# CITY OF ALBUQUERQUE

**Re: 512 Madison Pl SE,**  
**Request for Certificate of Occupancy - Approved**  
**Engineer's Stamp dated 06/07/11 (L-17/D001C)**  
**Certification dated 06-07-11**

**Re: 512 Madison Place SE  
Grading and Drainage Plan  
Engineer's Stamp dated 06-06-2010 (L17-D001C)**

**RE: Grading and Drainage Plan  
512 Madison Place SE (L17-D001C)**

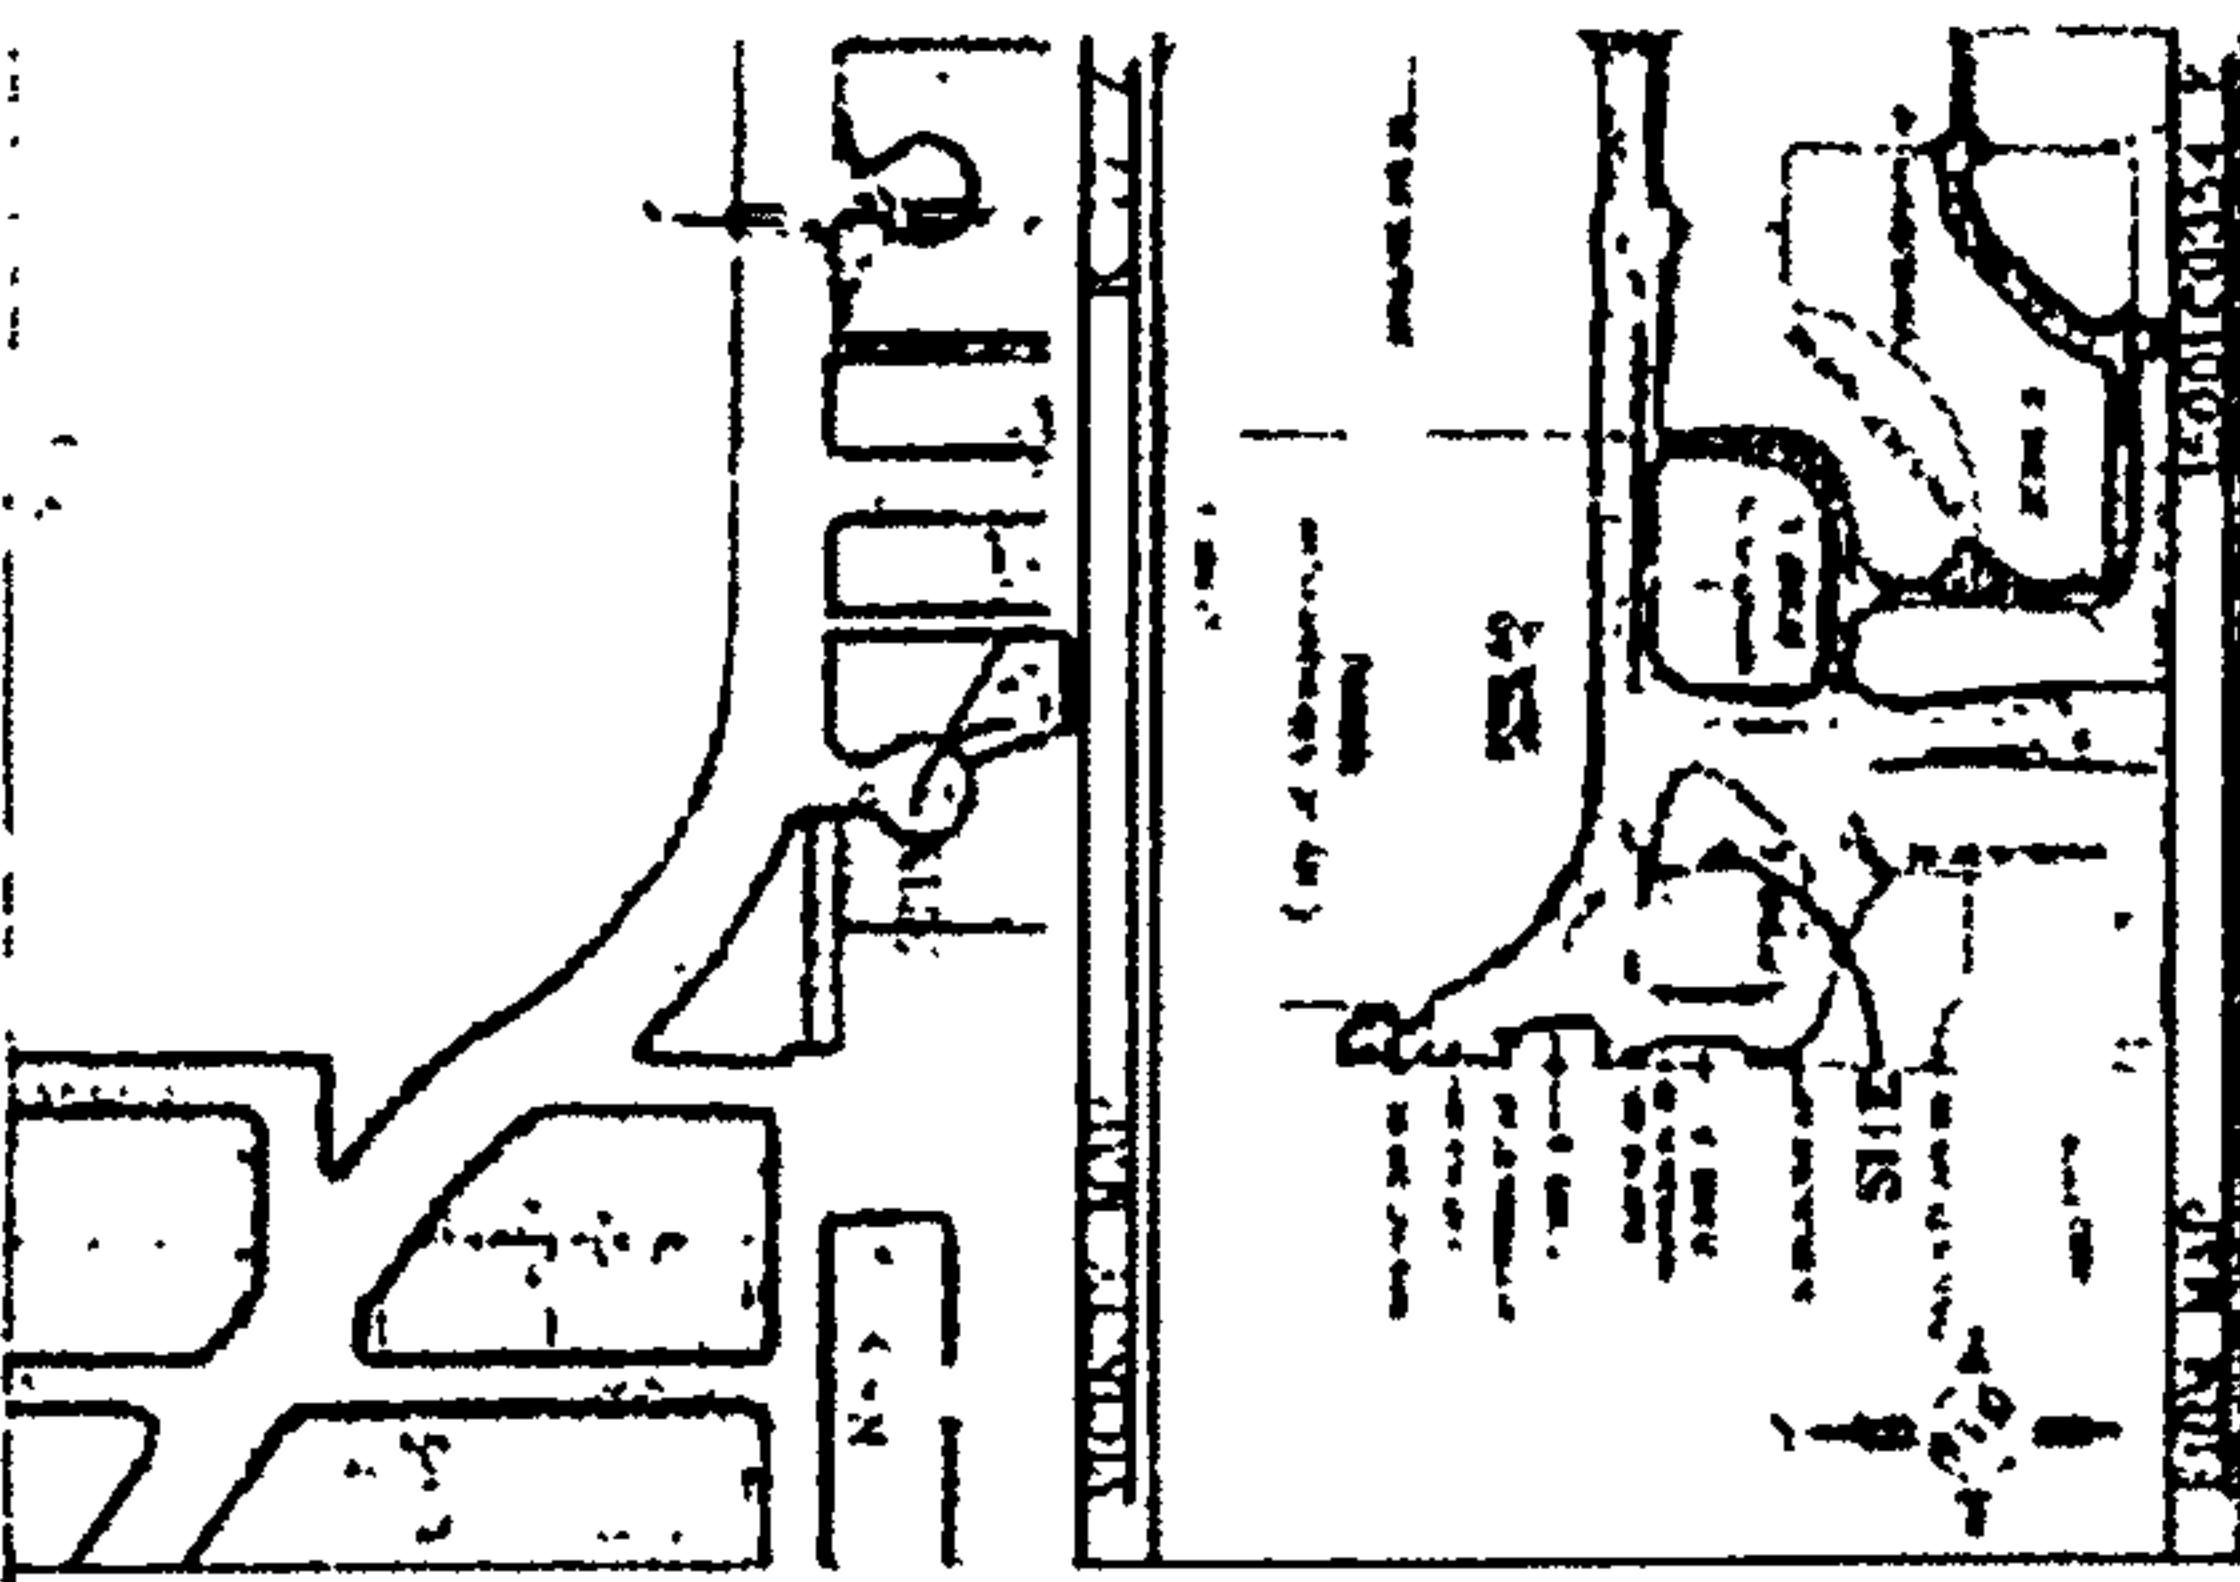
I have directed the restoration of existing flow within Right of Way as is shown in the supplemental as built.

I have drafted the restoration of existing flow within Rest of them as is shown in the supplemental as built.
